Bornish Wind Energy Centre Comparative Layout and Updated Natural Features

Re: Bornish Wind Energy Centre NHA Addendum V - Parkhill Interconnect Addendum

Parkhill Interconnect
Natural Heritage Assessment
Addendum Report

Parkhill Interconnect
Natural Heritage Assessment Addendum Report

Figure 2

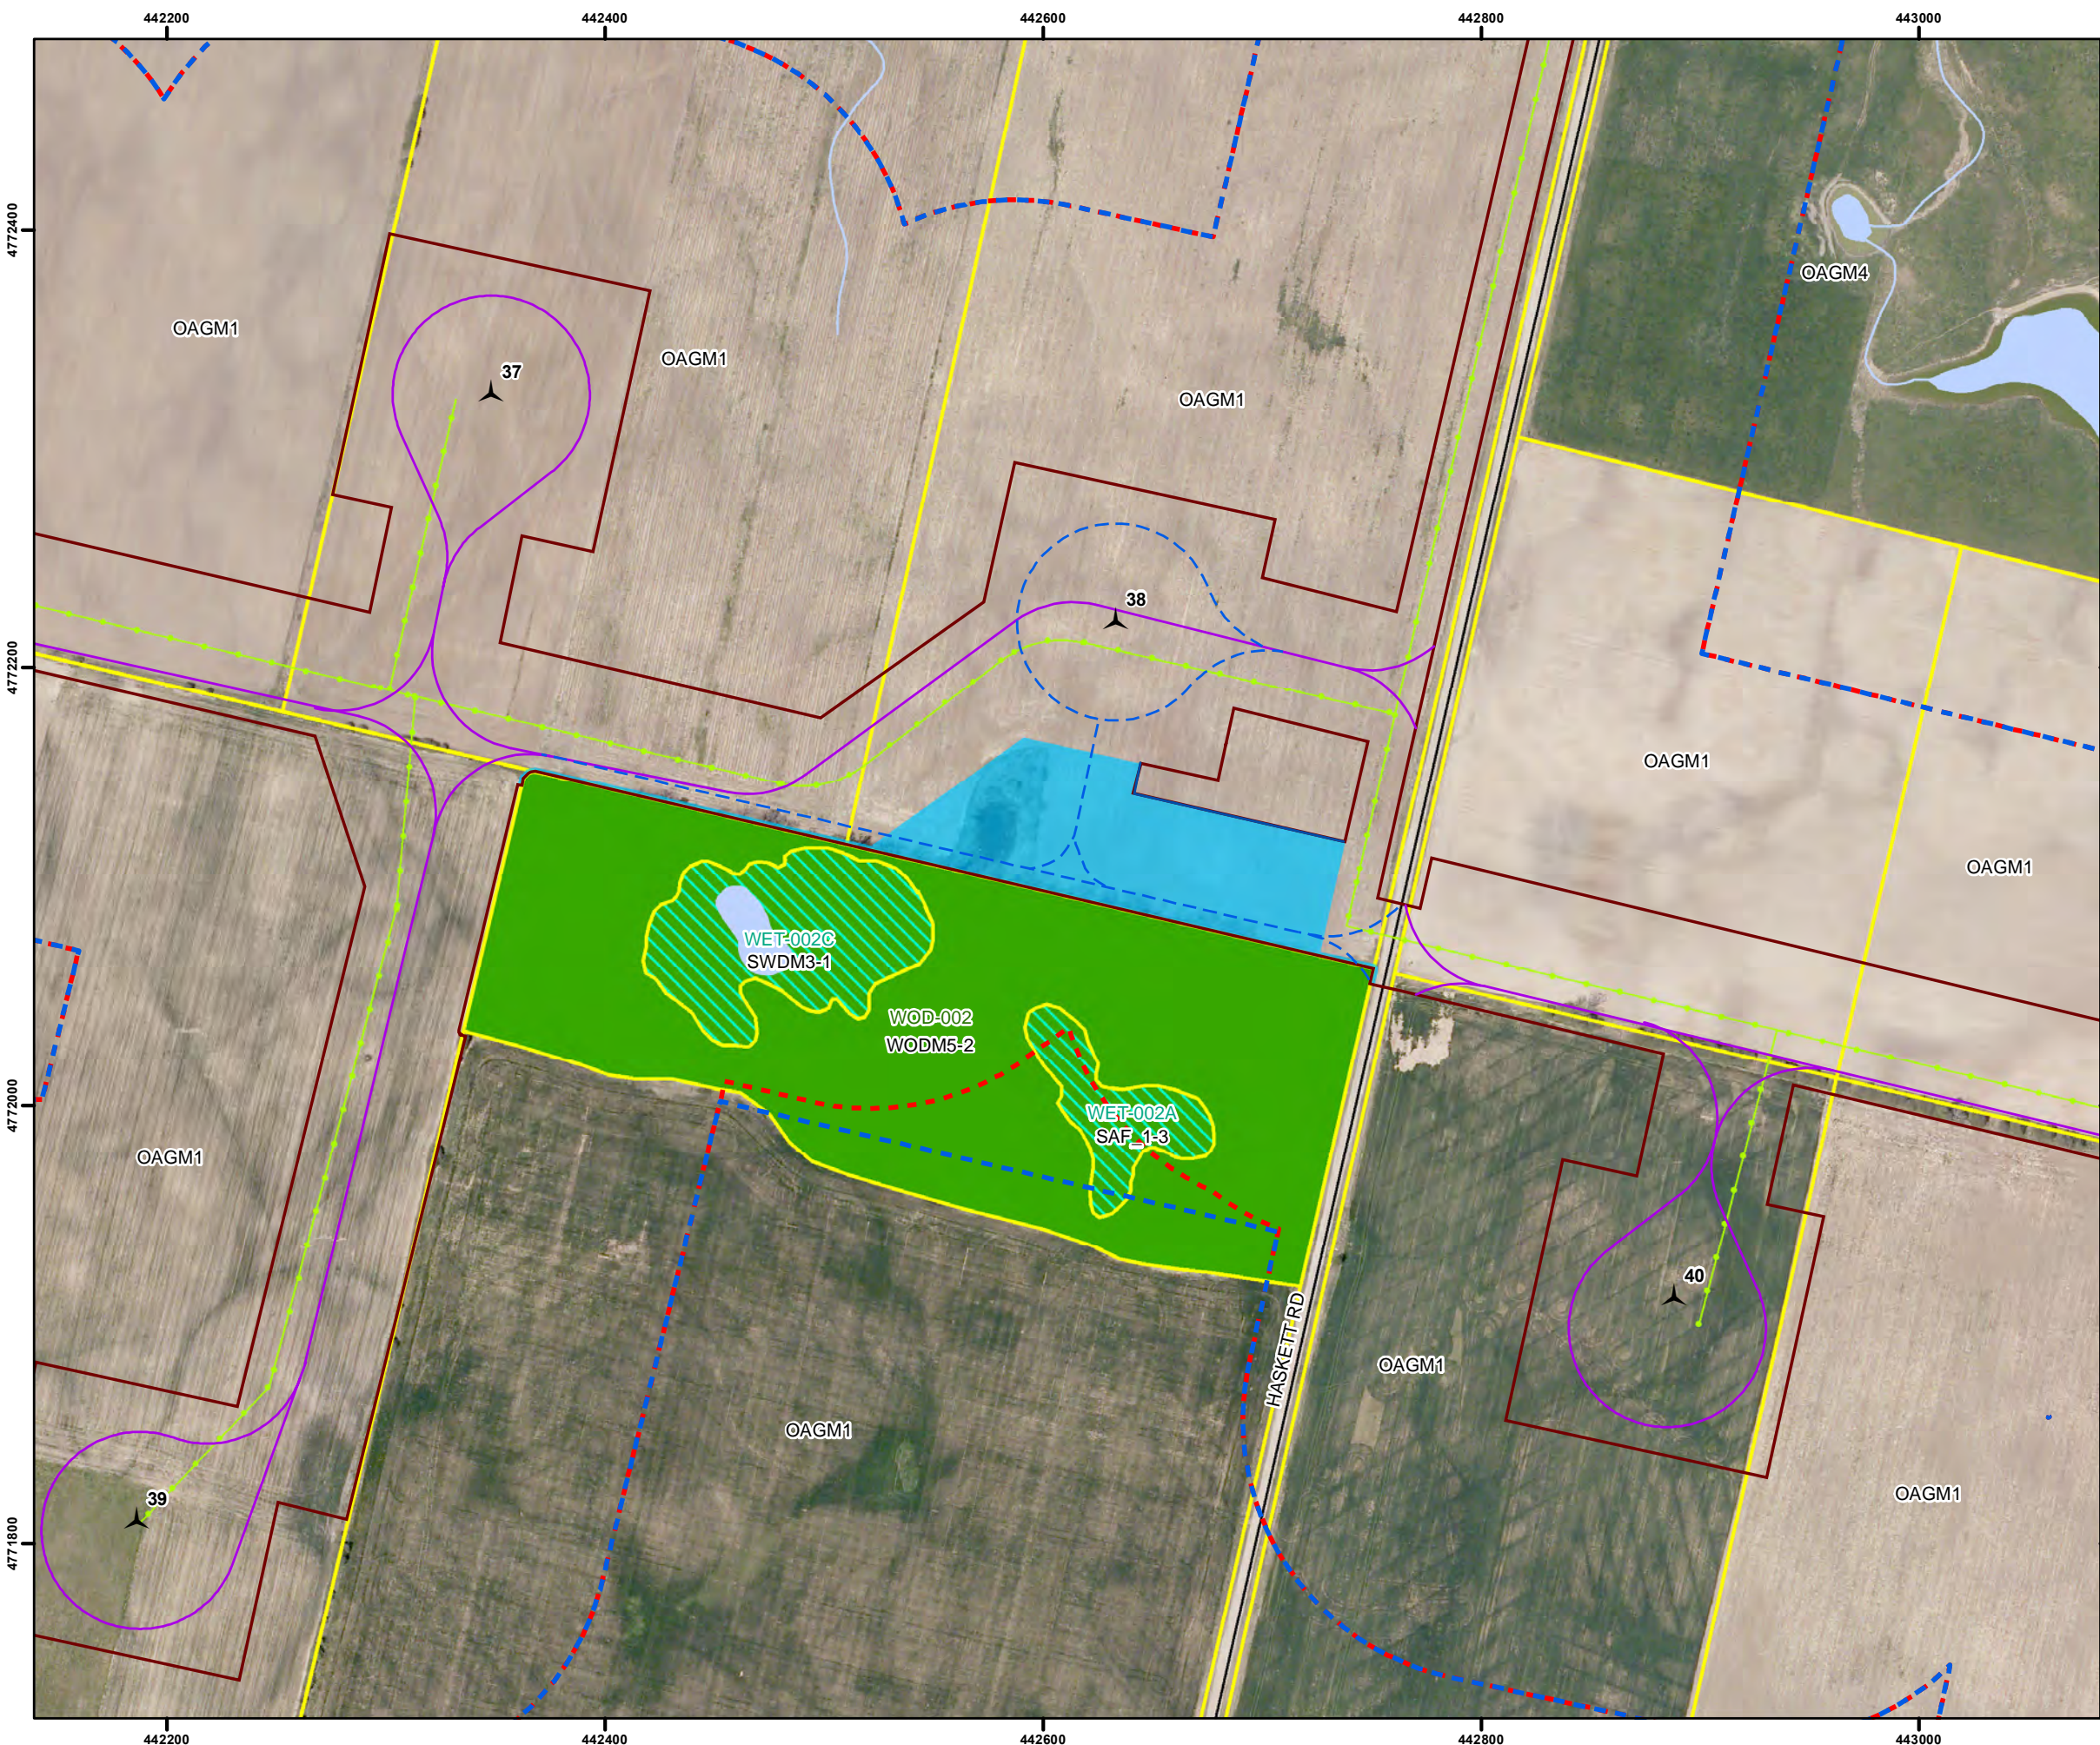
By reviewing the changes made to the Bornish Wind Energy Centre layout since its latest NHA confirmation, it has been verified that the proposed alteration to the project layout has only led to minor changes in distance between project components and natural features and has not resulted in any new features being included in the project area.

A wetland, assumed to be significant, (WET-002b) was previously identified in the area where the additional project location is now proposed. This portion of the larger wetland delineation was an open pond that was expected to be anthropogenic in origin, and was later confirmed by the landowner that it was installed as a pond for livestock. The landowner, who no longer has cattle on the property, has since decided to remove this open pond in favour of additional cropland. As a result, the existing project footprint is entirely within an agricultural field. A site investigation of this feature was completed on October 7, 2013 to re-confirm the boundaries of the feature and identify the current land use. The new boundaries are shown in Figure 2, and photographs taken of the current habitat can be found in Appendix I. The site investigation of this area has confirmed that it no longer contains standing water, does not support wetland vegetation (aside from a few remnant indicator species), nor does it have connectivity to the still-present, adjacent wetland habitat, WET-002c. As a result, NRSI has determined that the habitats previously delineated as wetland no longer qualify as wetland habitat and are now part of the surrounding agricultural field.
